HISTORIC AND DESIGN REVIEW COMMISSION

October 19, 2022

HDRC CASE NO: 2022-513
ADDRESS: 400 CLUB DR
LEGAL DESCRIPTION: NCB 7013 BLK LOT 9
ZONING: RM-4, H
CITY COUNCIL DIST.: 7
DISTRICT: Monticello Park Historic District
APPLICANT: Paul Zurita/Zurita Construction & Remodeling
OWNER: IDEA INTERNATIONAL LLC
TYPE OF WORK: Window replacement
APPLICATION RECEIVED: October 04, 2022
60-DAY REVIEW: Not applicable due to City Council Emergency Orders
CASE MANAGER: Jessica Anderson

The applicant requests a Certificate of Appropriateness for approval to replace the existing metal casement windows with wood windows and to replace the wood garage doors with an aluminum panel garage door.

Scope of Work:

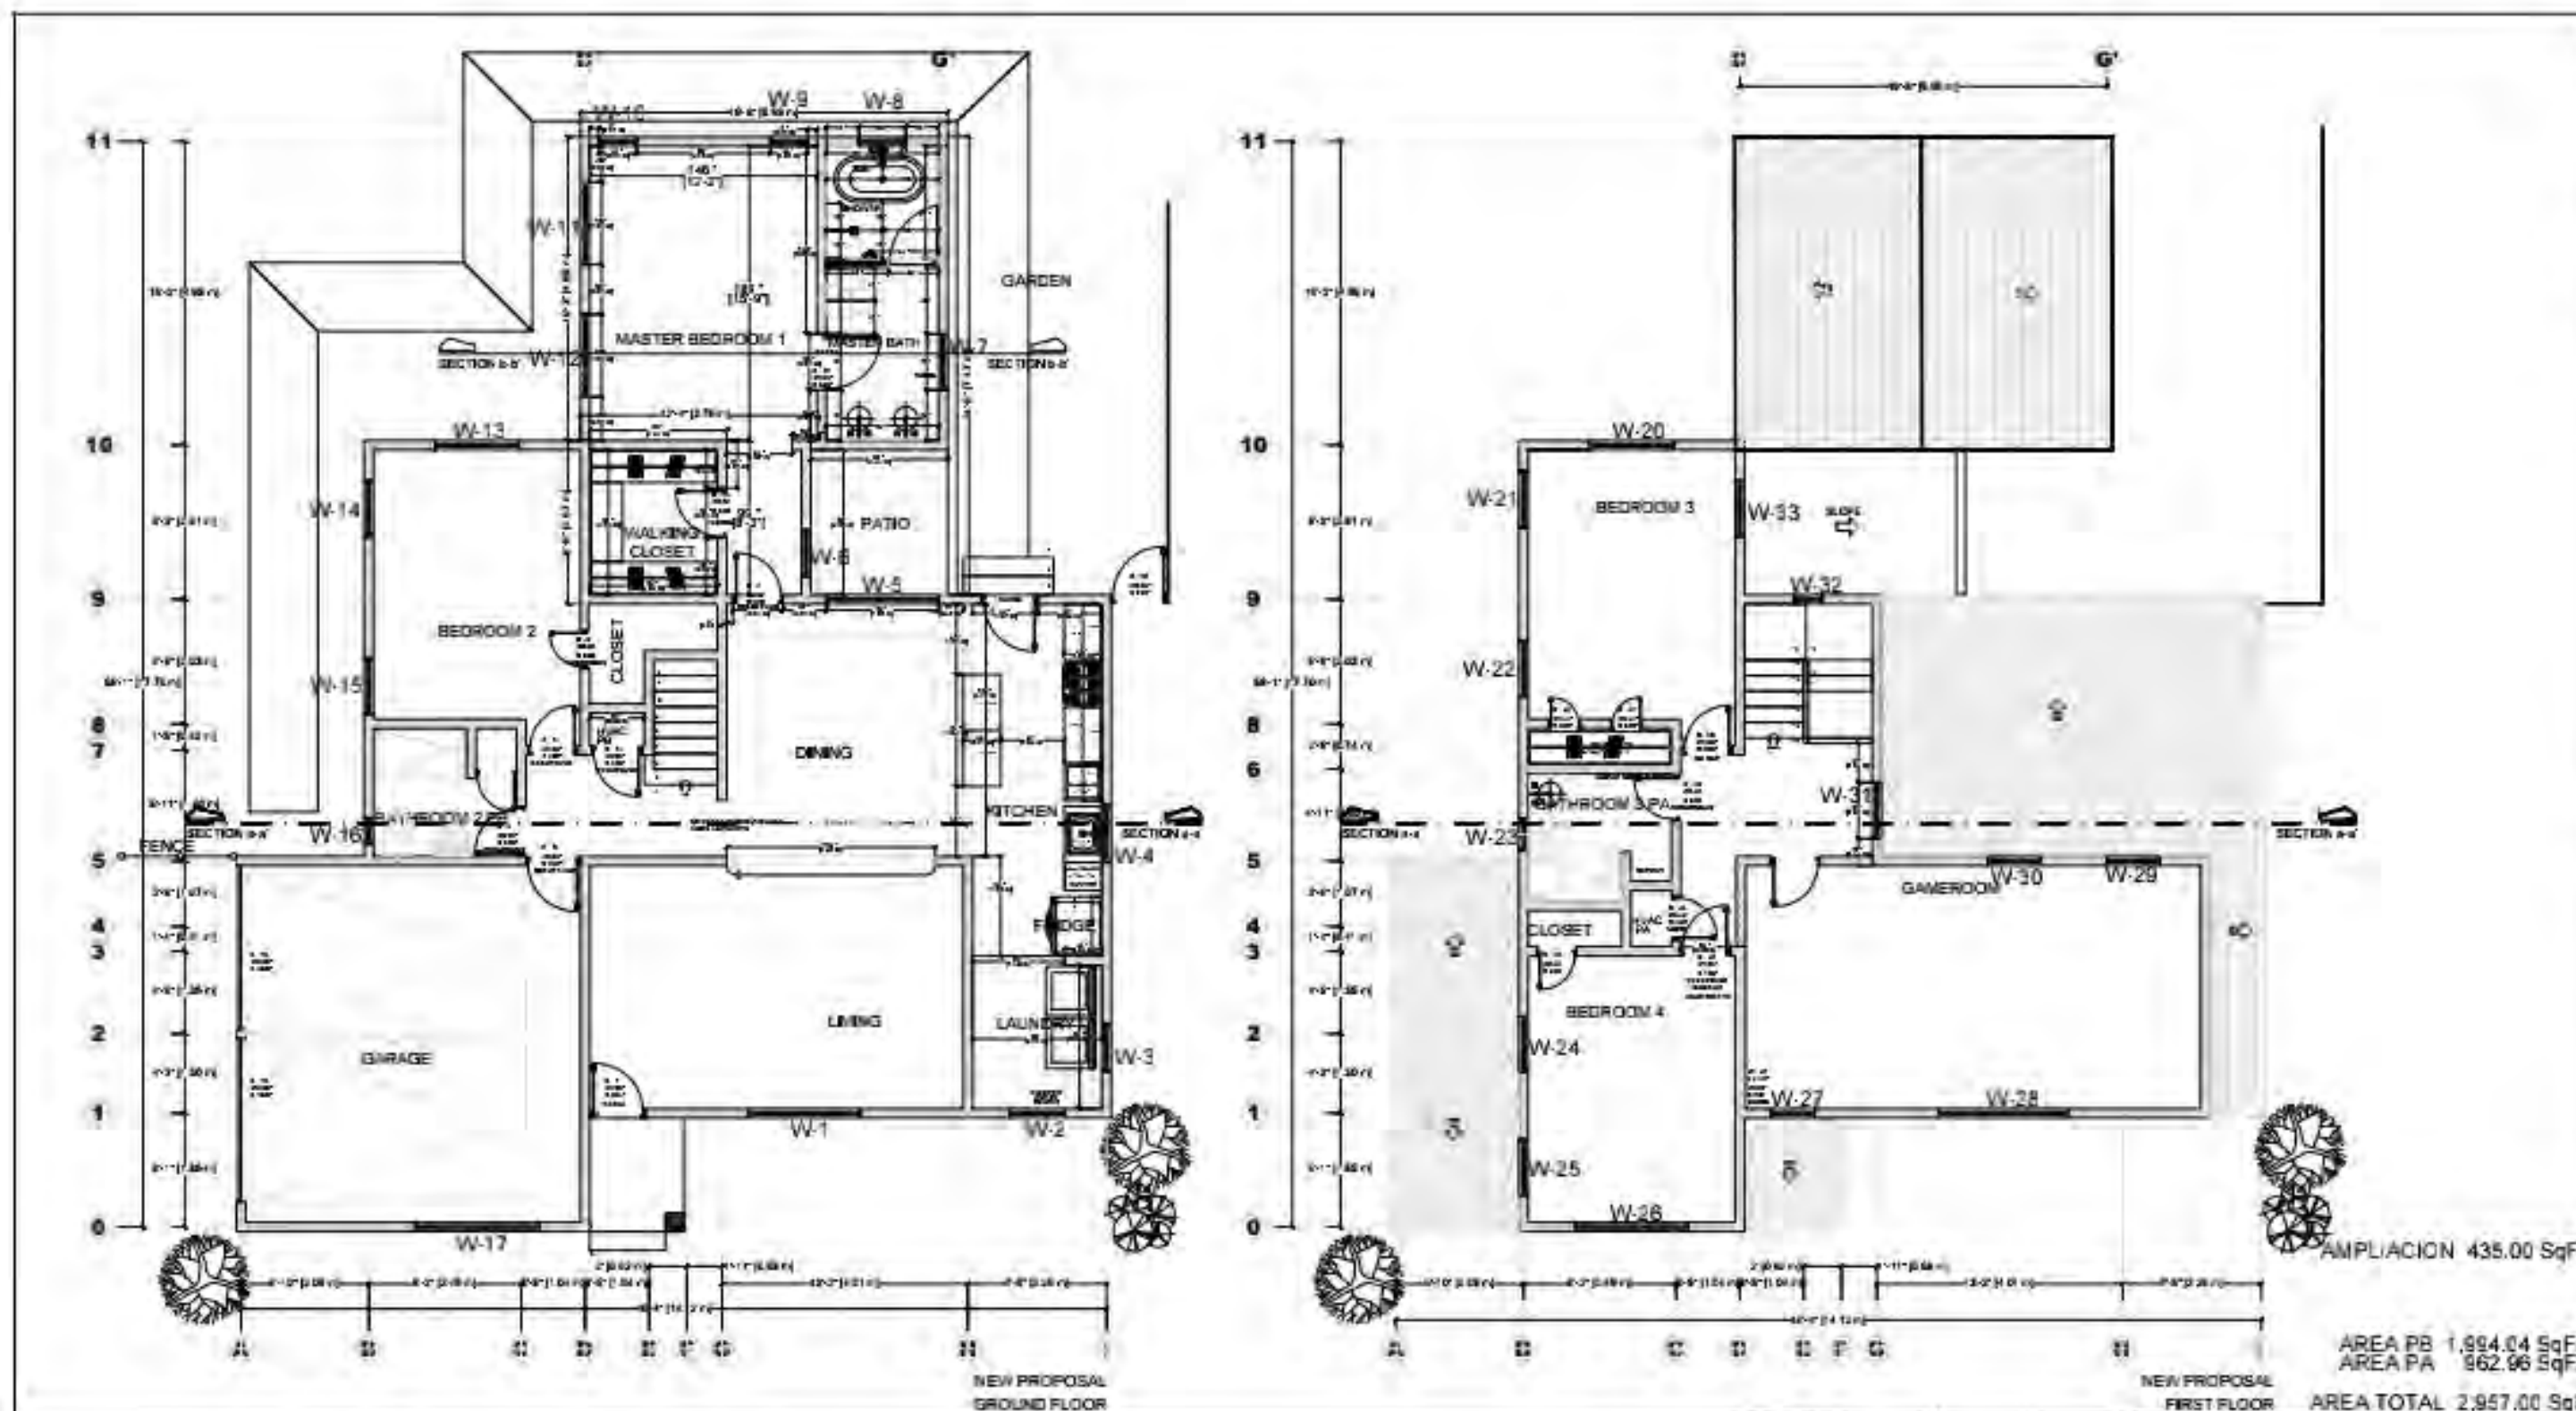
- c. **WINDOW REPLACEMENT:** The applicant requests to replace existing metal casement windows with aluminum-clad wood windows. Staff finds the request generally appropriate, but recommends the windows feature true divided lights without false muntins. Staff also recommends retention of the existing window dimensions as well as retention of the prominent lintels found above some of the first-story windows.

- d. **GARAGE DOORS:** The applicant requests to replace the existing wood garage doors with an aluminum panel door. Historic Design Guidelines for Exterior Maintenance and Alterations 9.B.i says to ensure replacement of garage doors are compatible with those found on historic garages in the district as well as with the principal structure. Staff finds the proposed aluminum garage door does not conform to guidelines. Per Guideline 9.B.i, since the garage is visible from the right-of-way, staff recommends a door compatible with those found on historic garages in the district, namely a wood-paneled door.

- 1. We were in the process of repairing the windows and we found the wood has rotted out in the majority of the windows and all need to be replaced with new windows. We will be replacing with aluminum windows with wood and wood frame, which the wood will be painted to match existing.**
- 2. We would also like to install a new Aluminum Garage Door (1 door in place of 2) we have attached a pic where the opening of the garage door will be placed with a new wood frame that will be painted to match the existing.**

Staff recommends approval of the request to replace metal casement windows with aluminum-clad wood windows based on finding c, with the following stipulations:

- i. That the windows feature true divided lites without false muntins.
- ii. That new windows retain the existing window dimensions.
- iii. That prominent lintels over first-story windows be retained where they are found.

Staff recommends approval of the request to replace the existing wood garage doors based on finding d, with the following stipulation:

- i. That the applicant propose a wood paneled garage door that conforms to guidelines.
